Reprogramming File Availability for Oil Level Detection

2013-2014 Legacy and Outback 2.5L Models

11-145-14R

Oil Level Switch

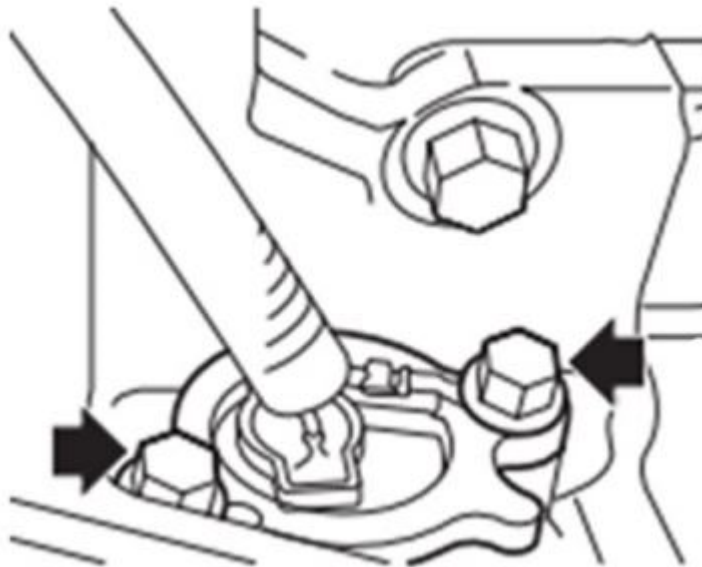
Step 3 – Once the ECM reprogramming has been completed and the oil level switch wiring has been confirmed to be OK, proceed with replacing the oil level switch assembly shown in the illustration below following the procedure outlined in the applicable Service Manual.

Torque the 2 retaining bolts to 6.4 Nm (56 inch-pounds).Torque the 2 retaining bolts to 6.4 Nm (56 inch-pounds).
